SERVICE BULLETIN

N° 139-738

ATA 53 – TAIL BOOM ASSY CORROSION PREVENTION IMPROVEMENT

Figure 1

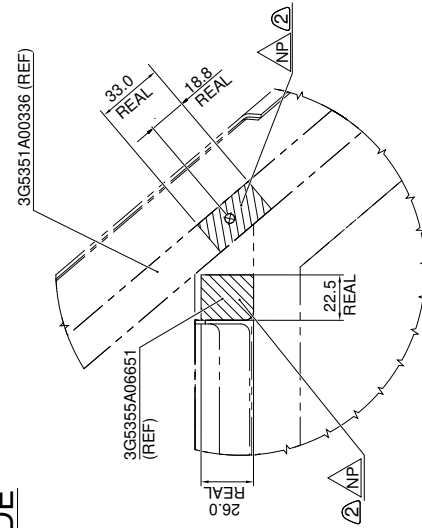
3. With reference to Figure 1 “View looking outboard left side”, remove existing anchor nut in the indicated position from the RW longeron assy P/N 3G5351A00336. Retain for later reuse.

4. In accordance with AMP DM 39-A-20-10-01-00A-259A-A and with reference to Figure 1 Detail A, prepare the indicated area on the RW longeron assy P/N 3G5351A00336 to assure the correct electrical bonding.

5. With reference to Figure 1 “View looking outboard left side”, install the bonding plate assy P/N 3G5318A63631 and the anchor nut previously removed (Ref. step 3) on the RW longeron assy P/N 3G5351A00336.

6. In accordance with AMP DM 39-A-20-10-01-00A-259A-A and with reference to Figure 1 Detail A, prepare the indicated area on the bonding rib P/N 3G5355A06651 to assure the correct electrical bonding.

7. With reference to Figure 1 "View looking outboard left side", install the bonding plate P/N 3G5355A09151 by means of n°2 rivets P/N A298A04TW02 on the trailing edge fairing assy P/N 3G5355A00137.

8. With reference to Figure 1 "View looking inboard left side", install n°1 ply of sealant tape (C405) to restore finishing surface between RW longeron assy P/N 3G5351A00336 and bonding rib P/N 3G5355A06651.

- ① RESTORE FINISHING SURFACE BETWEEN 3G5351A00336 RW LONGERON ASSY AND 3G5355A06651 BONDING RIB.
- ② REMOVE IN THE INDICATED AREA THE PROTECTIVE FINISH TO ASSURE GROUND CONTACT.

Figure 2

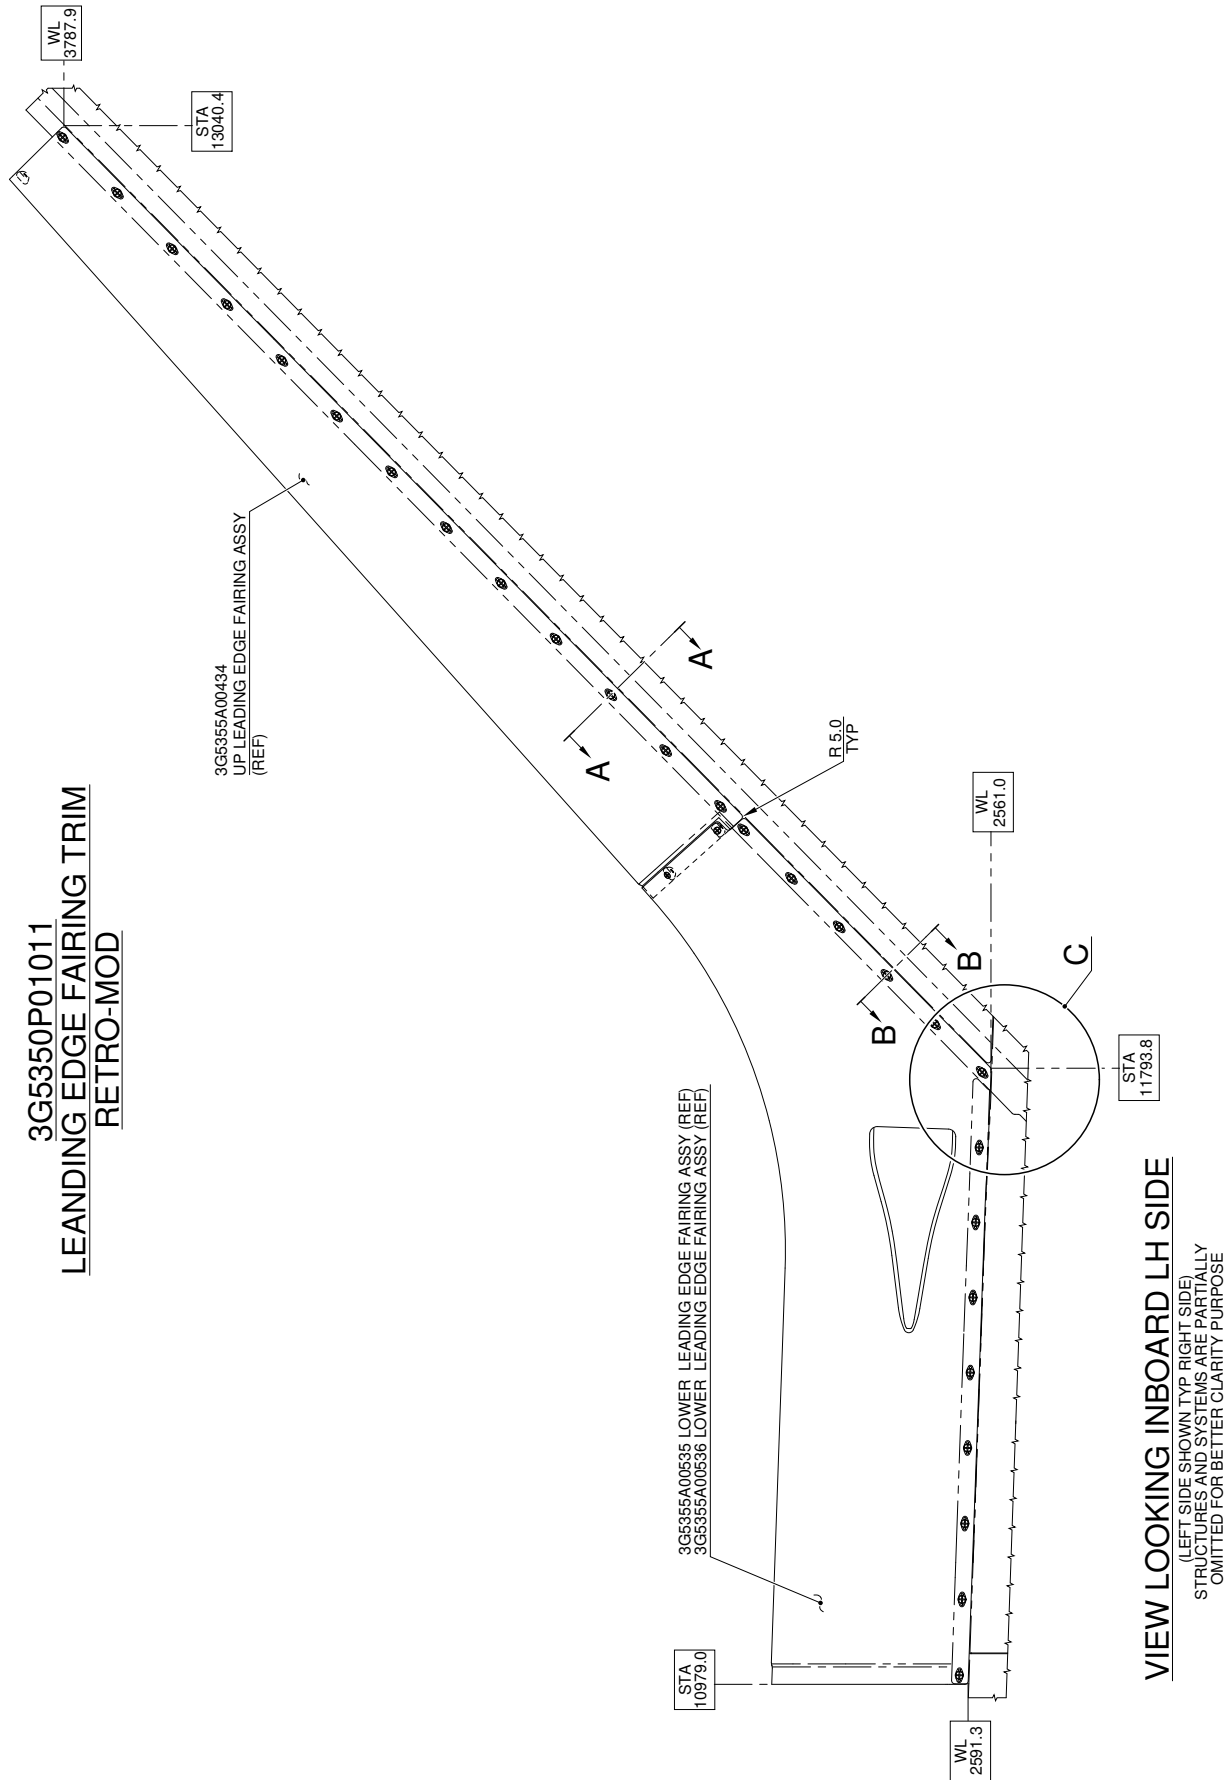
2. In accordance with AMP DM 39-A-06-41-00-00A-010A-A and with reference to Figure 2, remove the up leading edge fairing assy (access panel 360AL) P/N 3G5355A00434 and the lower leading edge fairing assy (access panel 313AL) P/N 3G5355A00535 or P/N 3G5355A00536 from the tail boom assy.

7. In accordance with AMP DM 39-A-06-41-00-00A-010A-A and with reference to Figure 2, reinstall the up leading edge fairing assy (access panel 360AL) P/N 3G5355A00434 and the lower leading edge fairing assy (access panel 313AL) P/N 3G5355A00535 or P/N 3G5355A00536 on the tail boom assy.

Figure 3

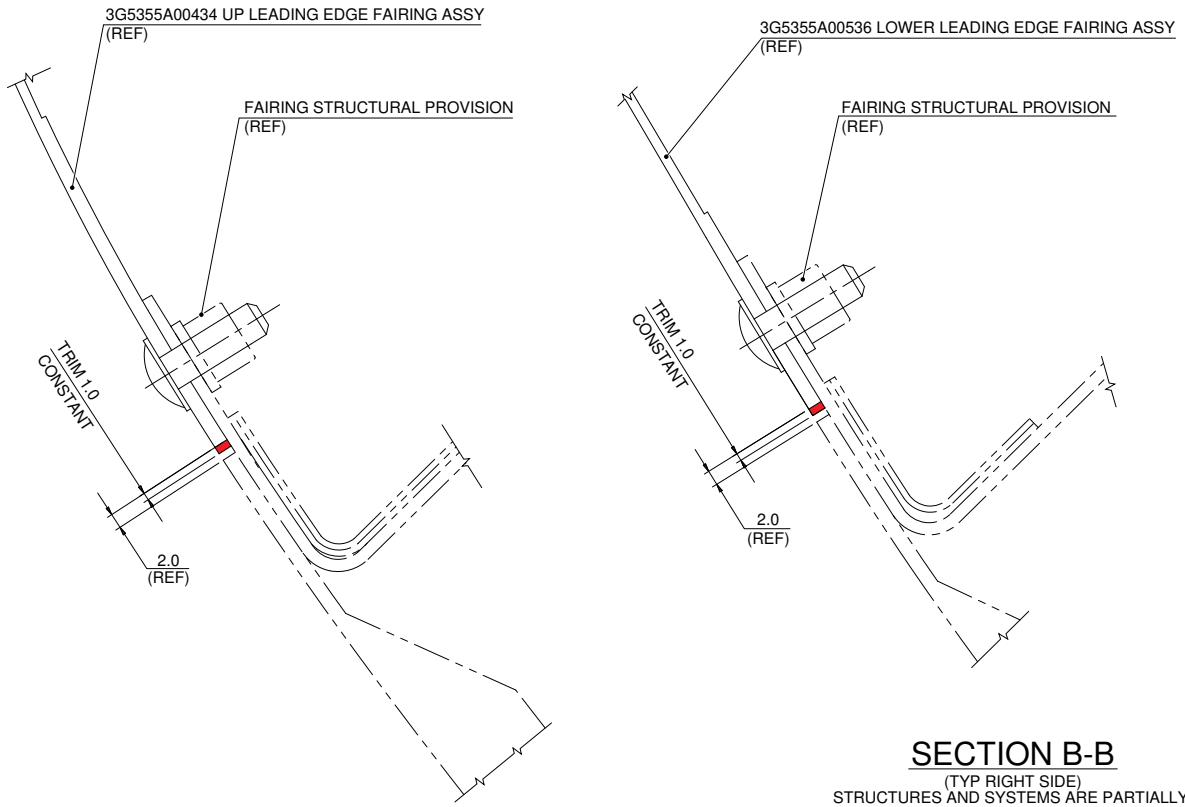
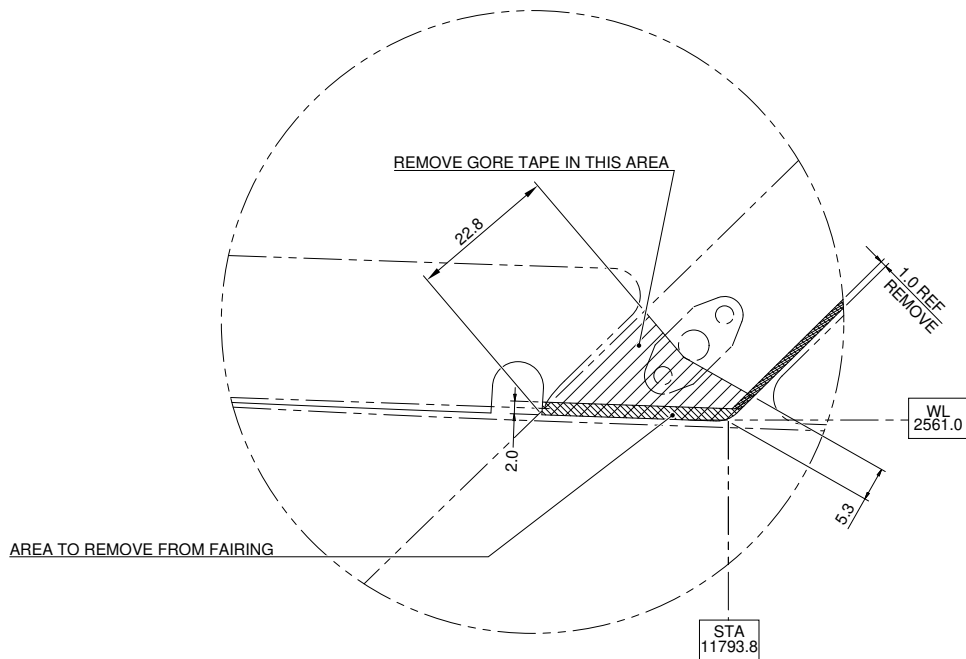
3. With reference to Figure 3 Section A-A, trim the up leading edge fairing assy P/N 3G5355A00434 as indicated.
4. With reference to Figure 3 Section B-B, trim the lower leading edge fairing assy P/N 3G5355A00535 or P/N 3G5355A00536 as indicated.

5. With reference to Figure 3 Detail C, trim the lower leading edge fairing assy P/N 3G5355A00535 or P/N 3G5355A00536 as indicated.
6. With reference to Figure 3 Detail C, remove gore tape from the indicated area.
